Arboricultural Construction Impact Assessment

19 Regent Ave, Springvale VIC 3171

Date of Report 27/06/2024

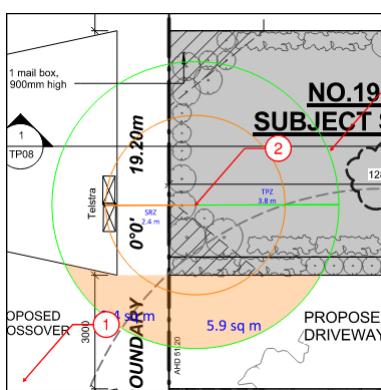
- Tree 1 is a semi-mature, Victorian native White Bottlebrush of medium retention value and moderate significance, located in the road reserve of Regent Ave. The tree is codominant and has acutely bifurcated unions with included bark present in the stem.

There is no existing encroachment within the TPZ.

The tree is within the footprint of the proposed crossover and cannot be retained.

The tree is proposed to be demolished and will require approval by the responsible authority to remove.

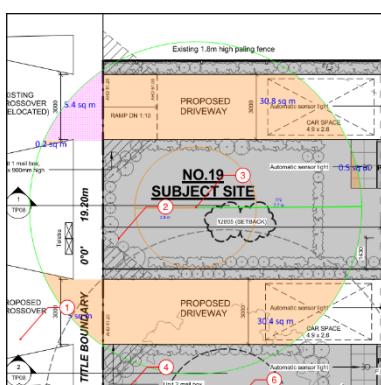
- Tree 2 is a mature, non-native Photinia of medium to high retention value and moderate significance, located on the subject site. The tree is of typical health and structure for its species, age, and location.

Within the context of the proposed design, the tree will incur an approximate 9.3m^2 (20%) combined TPZ area impact and an impact of the SRZ from the proposed

- Crossover, 3.4m^2 (7%) semi-prohibitive impact
- Driveway, 5.9m^2 (13%) semi-prohibitive impact (SRZ impact)

This is a major TPZ area encroachment in accordance with AS4970-2009. The tree is proposed to be demolished and will not require approval by the responsible authority to remove as it has a trunk diameter less than 40 cm measured at 1.4 meters above ground level.

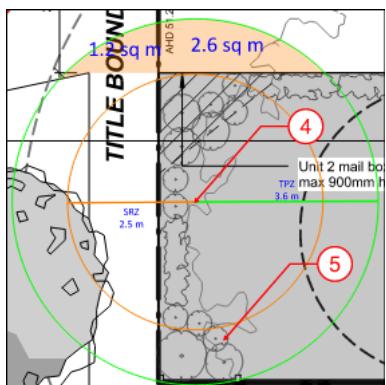
- Tree 3 is a mature, non-native American Sweetgum of low retention value and moderate significance, located on the subject site. The canopy of the tree is composed of epicormic stems due to lopping. There are multiple failures throughout the canopy from epicormic stems. The apically dominant stem has failed. There are cavities throughout the stem and canopy.

There is 5.4m^2 existing semi-prohibitive encroachment within the TPZ from the crossover.

66.9m^2 (36%) combined TPZ area impact from the proposed

- Crossovers, 5.2m^2 (3%) semi-prohibitive impact
- Unit 1 driveway, 30.8m^2 (16%) semi-prohibitive impact

- c) Unit 2 driveway, 30.4m² (16%) semi-prohibitive impact
- d) Unit 1 pathway, 0.5m² (<1%) semi-prohibitive impact

This is a major TPZ area encroachment in accordance with AS4970-2009. The tree is proposed to be demolished and will require approval by the responsible authority to remove.

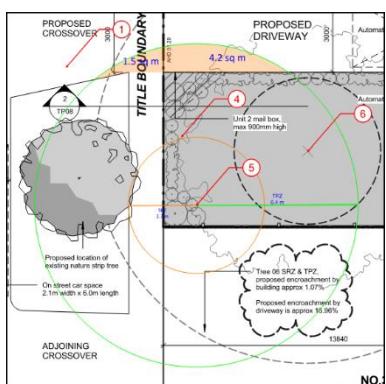
- **Tree 4** is a mature, Victorian native Lilly-Pilly of medium to low retention value and moderate significance, located on the subject site. The canopy of the tree is asymmetrical due to crowding by nearby trees. The entirety of the tree is composed of epicormic stems due to coppicing.

There is no existing encroachment within the TPZ.

Within the context of the proposed design, the tree will incur an approximate 5.7m² (4%) combined TPZ area impact from the proposed

- a) Crossover, 1.2m² (3%) semi-prohibitive impact

- b) Unit 2 driveway, 2.6m² (6%) semi-prohibitive impact

This is a minor TPZ area encroachment in accordance with AS4970-2009. The tree is proposed to be demolished and will not require approval by the responsible authority to remove as it has a trunk diameter less than 40 cm measured at 1.4 meters above ground level.

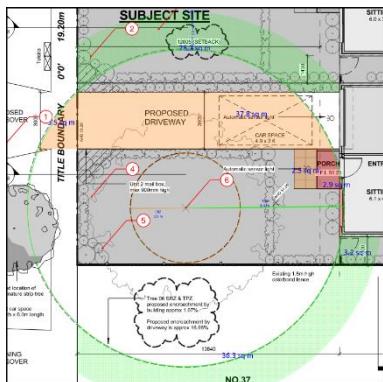
- **Tree 5** is a mature, Victorian native Narrow-leaved Peppermint of low retention value and low significance, located on the subject site. The tree is showing symptoms of late physiological decline. The canopy of the tree is asymmetrical due to crowding by nearby trees. There are cavities throughout the stem and canopy.

There is no existing encroachment within the TPZ.

Within the context of the proposed design, the tree will incur an approximate 5.7m² (4%) combined TPZ area impact from the proposed

- a) Crossover, 1.5m² (1%) semi-prohibitive impact

- b) Unit 2 driveway, 4.2m² (3%) semi-prohibitive impact

This is a minor TPZ area encroachment in accordance with AS4970-2009. The tree is proposed to be demolished and will require approval by the responsible authority to remove.
